PREPARED FOR THE PLAN COMMISSION AND URBAN DESIGN COMMISSION

Project Address: 7933 Tree Lane (9th Aldermanic District, Alder Skidmore)
Application Type: Planned Development Rezoning
Legistar File ID #: [40665](#)
Prepared By: Heather Stouder, AICP, Planning Division
Report Includes Comments from other City Agencies, as noted

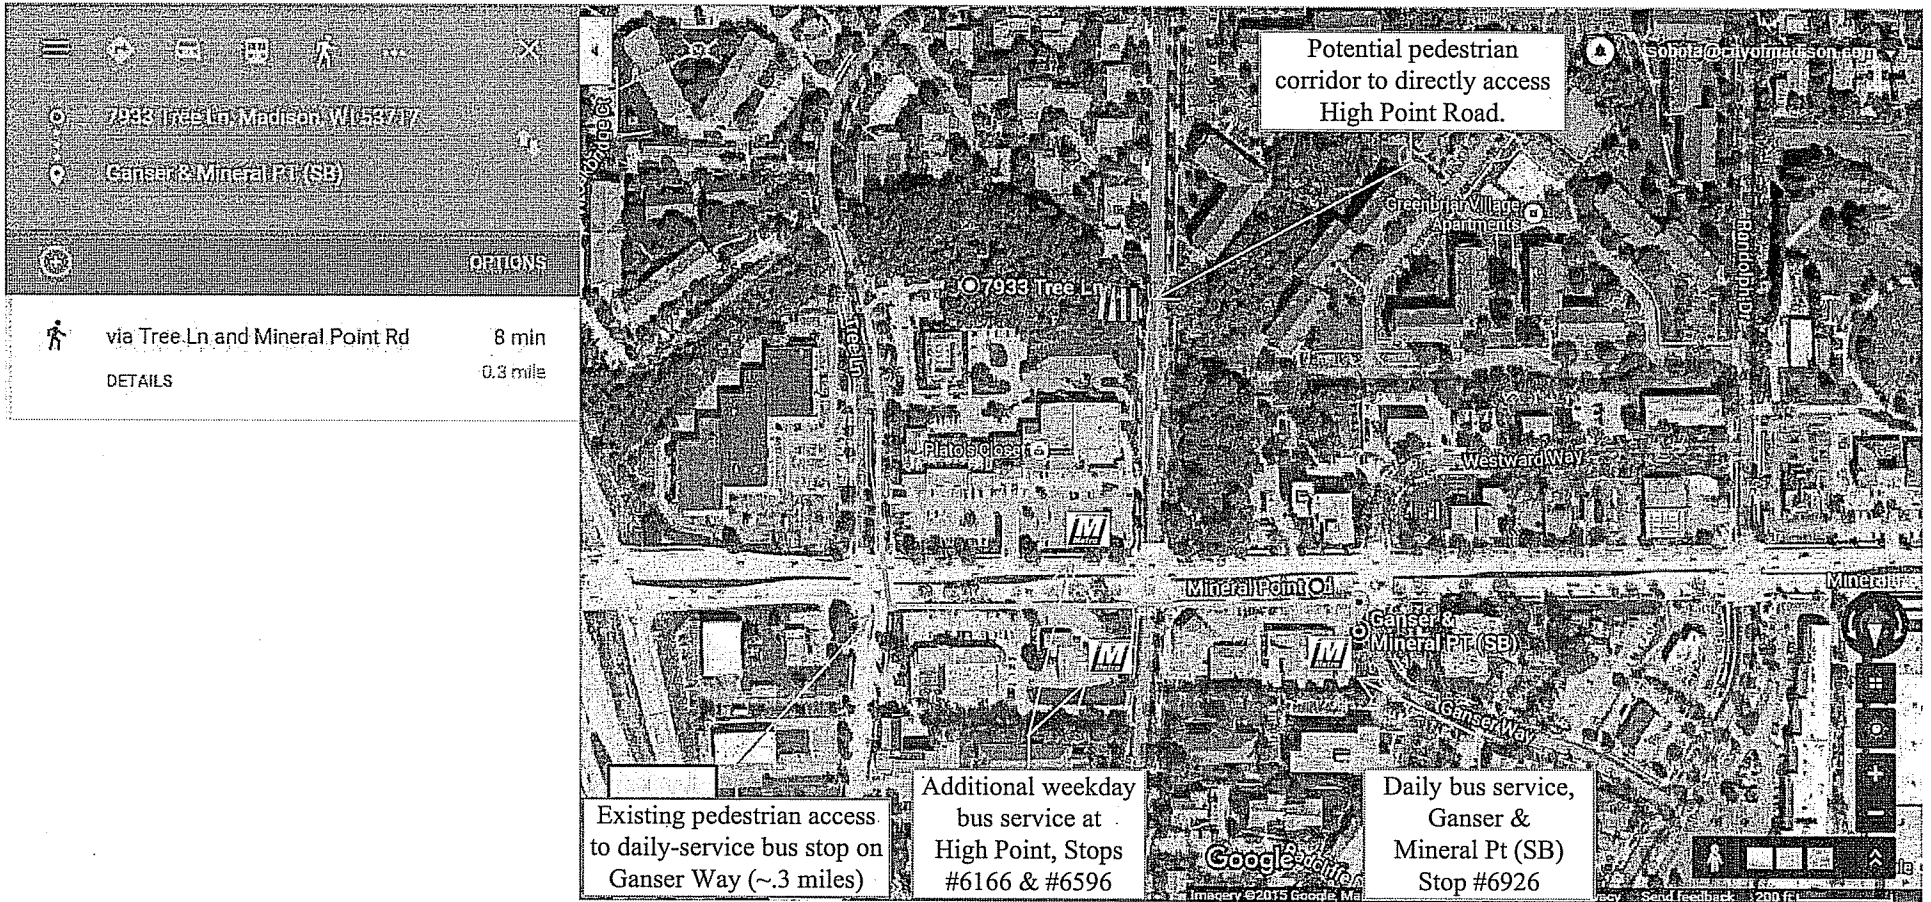
34. Metro Transit does not provide daily bus service within 1/4 mile walking distance of the proposed site. The closest bus stop with daily bus service is on Ganser Way, south of the Mineral Point Road intersection (one block east of High Point Road).
35. The applicant should seek to coordinate with the City of Madison to provide an accessible pedestrian connection running east from the site (using adjacent public greenway) to connect the project with High Point Road. This connection would significantly reduce the walking distance between the project and the existing bus stop on Ganser Way.
36. Metro Transit provides additional, weekday-only, bus service in the intersection of Mineral Point Road and High Point Road. [See attachment "7933tl_METRO.pdf"]

Potential pedestrian corridor to directly access High Point Road.

Existing pedestrian access to daily-service bus stop on Ganser Way (~.3 miles)

Additional weekday bus service at High Point, Stops #6166 & #6596

Daily bus service, Ganser & Mineral Pt (SB) Stop #6926
